ORDINARY COUNCIL MEETING - 25 MAY 2021

Attachment 1 - Consideration of Representations to Draft Amendment AMD 2021/01

Figure 1 - Swansea Structure Plan area
(reproduced from Integrated Assessment Report for All Stages, p9)

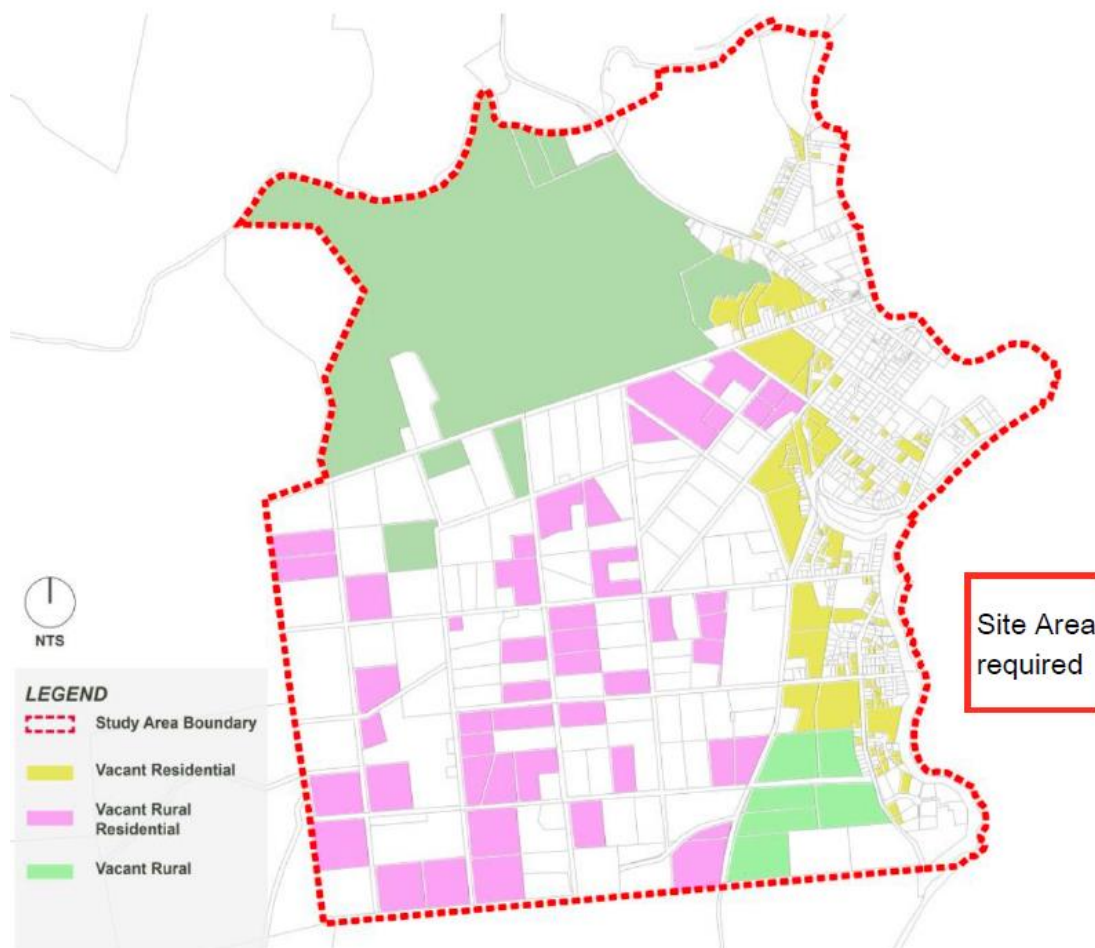
Arguments within the representations suggest that the vacant land in Figure 1 should be used for the project. Simple visual analysis confirms that the available vacant residential and rural residential lands are not large enough to support the project, nor are identified rural parcels to the southern side of Swansea.

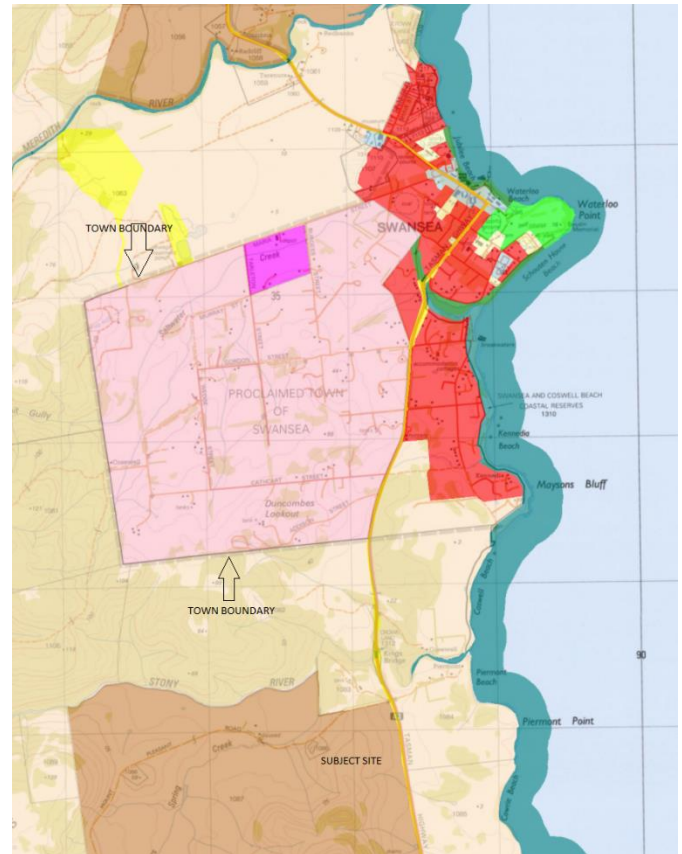
The representor claims there is an alternative site to the north of Swansea of approximately 150 hectares. Review of this site identifies that it is subject to limitations from the adjoining sewerage treatment plant. The following image displays this land with the overlays under the Interim Scheme and identifies a potential area of some 85 hectares, considering overlays and buffers under the planning scheme (green area and blue circles around sewerage treatment plant). Other potential sites are also identified but were not large enough to contain the proposal.

The subject lands would still require a process similar to the current site and were not selected by the proponents. While such sites may have potential to accommodate large scale uses, they are outside the current application and do not affect the previous assessment.
